## 1.0 TECHNICAL MEMO – STORMWATER

<b>To:</b>	Stacey Sharp & Blair Masefield, Beca (consultant planners)
<b>From:</b>	John McLaren, Senior Civil Engineer, Haigh Workman Limited
<b>Ref:</b>	Northland Regional Council: APP.005055.38.01 Whangārei District Council: LU2200107
<b>Date:</b>	16 November 2023

The purpose of this supplementary memorandum is to respond to technical matters, pertaining to stormwater, raised during initial hearings proceedings.

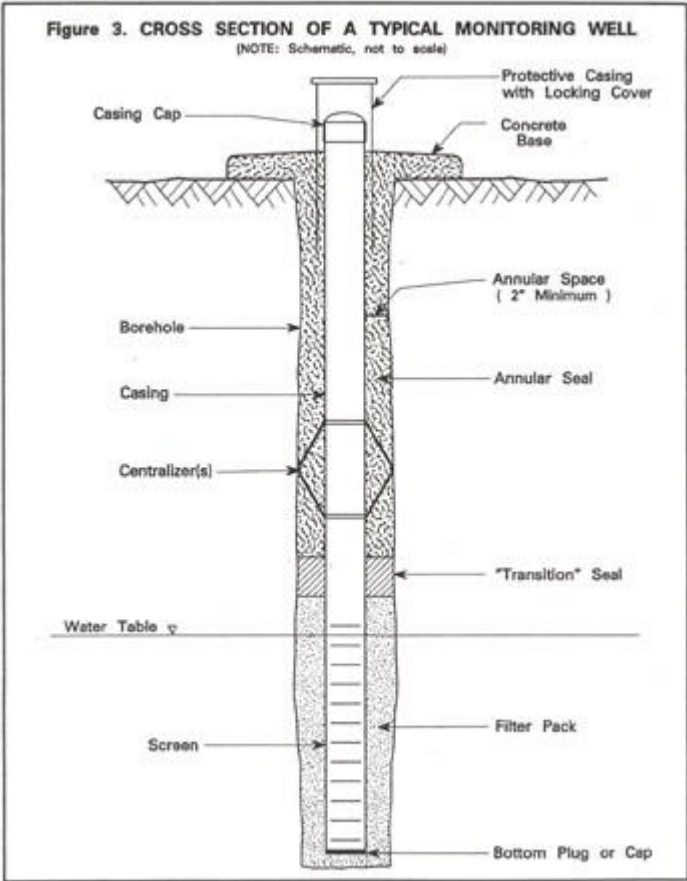
While the sand lining in canals is replaced annually and forebay maintained annually, there is currently no visibility over effects, if any, of the impact on discharge to groundwater.

I recommend that a groundwater monitoring and management plan be a consent condition. The groundwater monitoring and management plan may include monitoring wells – example below.

I understand that there may be contaminated groundwater plumes from the refinery site. If contaminated groundwater is identified in the wells, further investigation may be required to identify the source of contamination.
